**STAFF REPORT**  
**COMMUNITY DEVELOPMENT DEPARTMENT**

HEARING DATE: 12/22/2020  
TO: Mayor & City Council  
FROM: Alan Tiefenbach, Associate Planner  
208-489-0573  
SUBJECT: FP-2020-0012  
Chukar Ridge Final Plat  
LOCATION: The site is located at 4005 N. McDermott Rd., in the NE ¼ of Section 32, Township 4 N., Range 1W.

Final plat consisting of 63 buildable lots and 8 common lots on 15.42 acres of land in the R-8 zoning district.

## B. Final Plat (date: 11/3/2020)

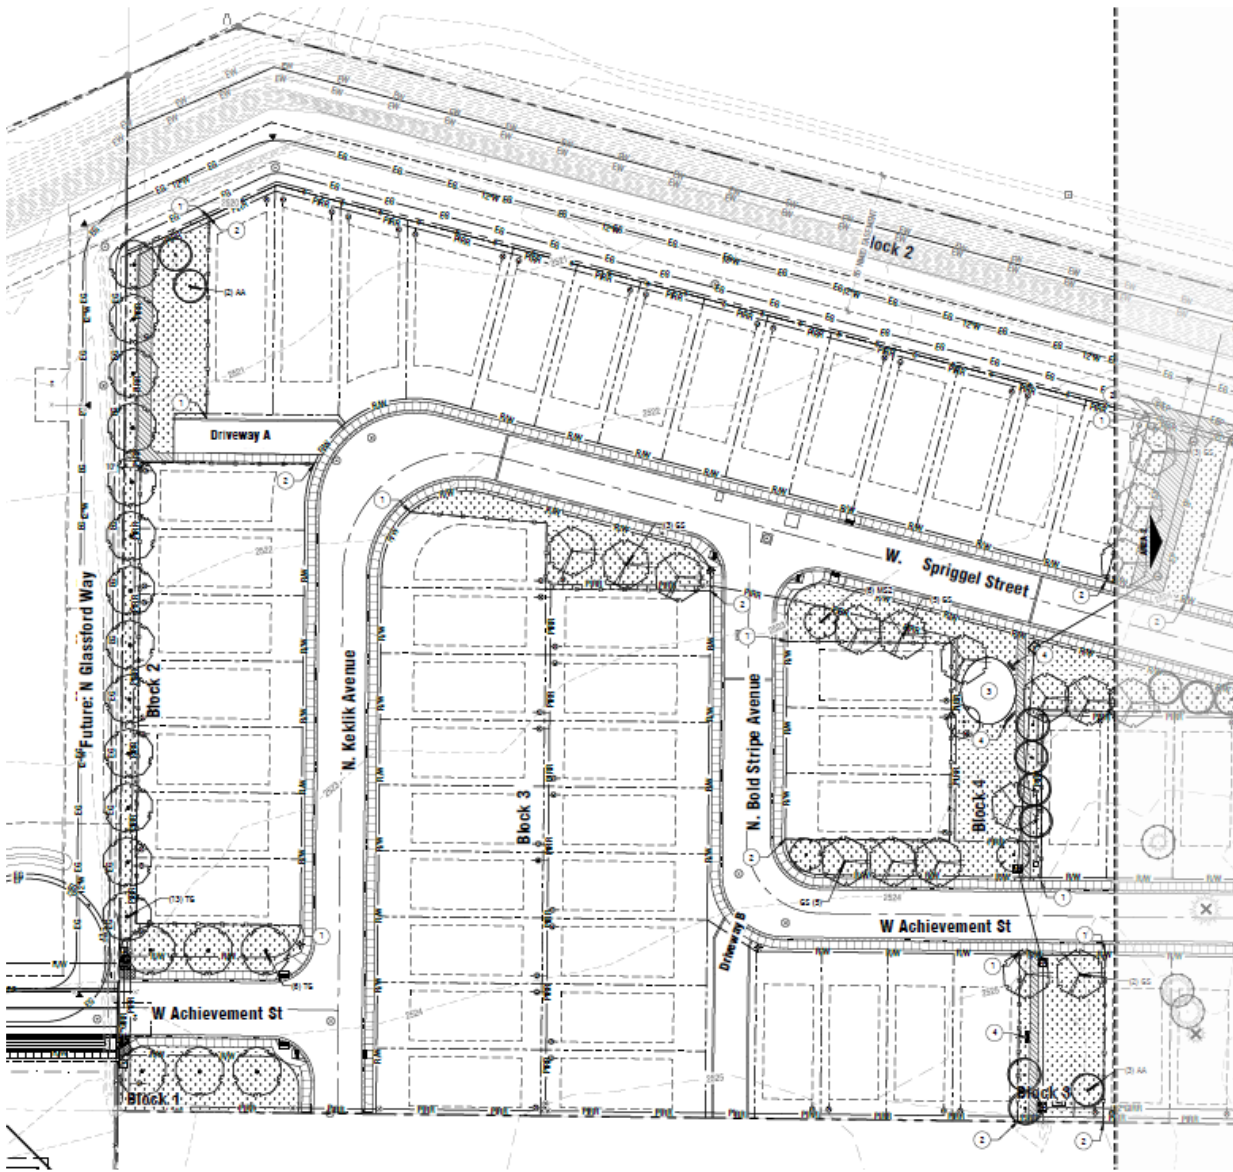
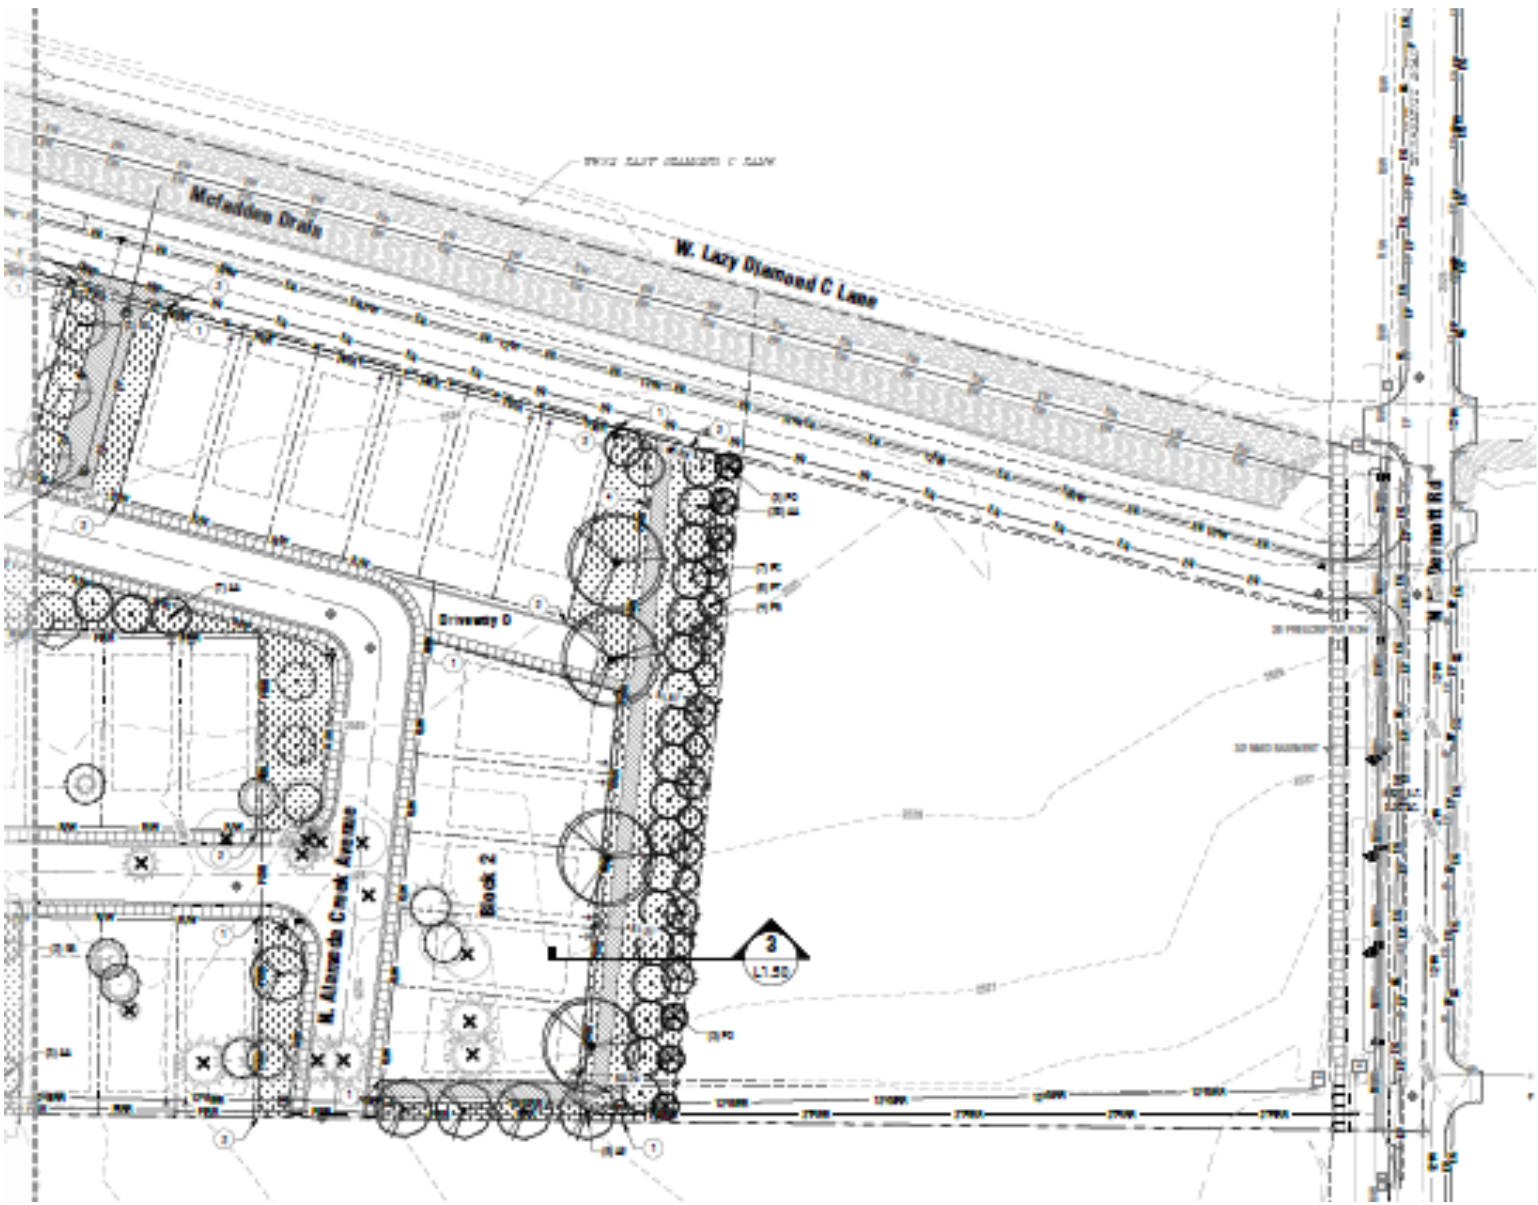
3. Prior to City Engineer signature on the final plat, the final plat prepared by the Land Group, LLP, stamped by James R. Washburn, dated: 11/3/2020, included in Section VI shall be revised as follows:

- a. Add Lot 10, Block 3 to Note 7.
  - b. Note #8 shall be revised to be owned and maintained by the Chukar Ridge homeowner's association.
  - c. Note #12, 14 and 15, insert instrument numbers.

C. Landscape Plan (date: 11/3/2020)

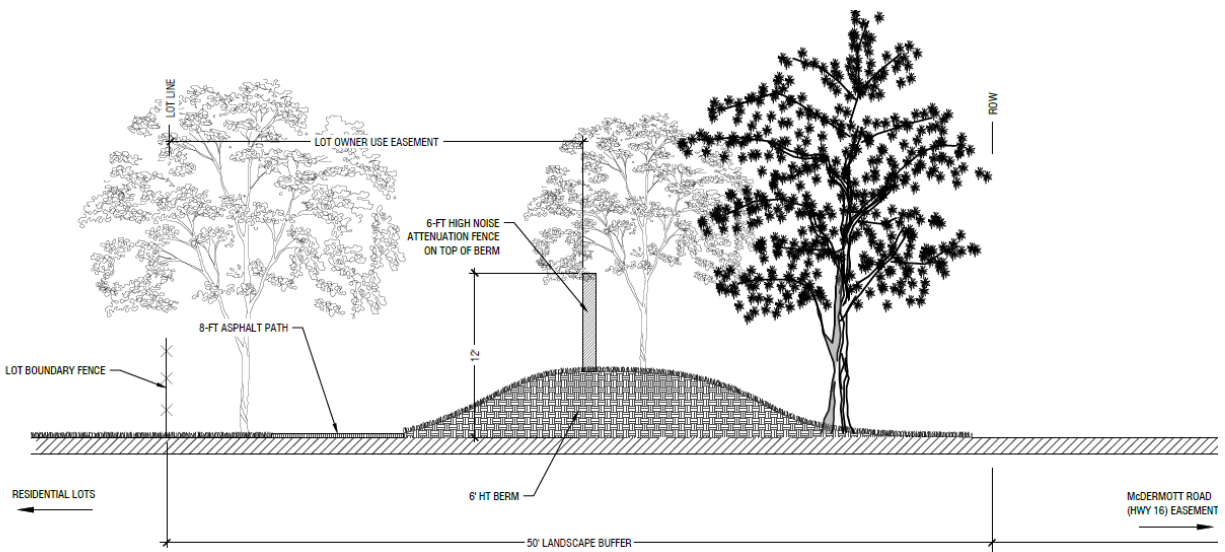
5. Prior to the City Engineer signature on the final plat, the landscape plan, prepared by the Land Group, dated 11/03/2020, included in Section VI shall be revised as follows:

- a. Depict 5-foot wide landscaped buffers to separate the paved surface of the driveway from the fence on all common driveways which contain solid fencing per UDC 11-6C-3D.5.

- b. Revise fencing along all common lots and pathways to be open vision or less than 4' in height as required by UDC 11-3A-7. This includes the east boundary of Lot 1, Block 2, the south boundary of Lot 10, Block 3, the east boundary of Lots 23-36, the western boundary of Lot 37, Block 2 and south boundary of Lot 36, Block 2.

- c. Provide fencing along the southern perimeter of the development.
  - d. Indicate how the McFadden Lateral will be landscaped as allowed by the irrigation district, or provide a documentation from the district that landscaping is not permitted.
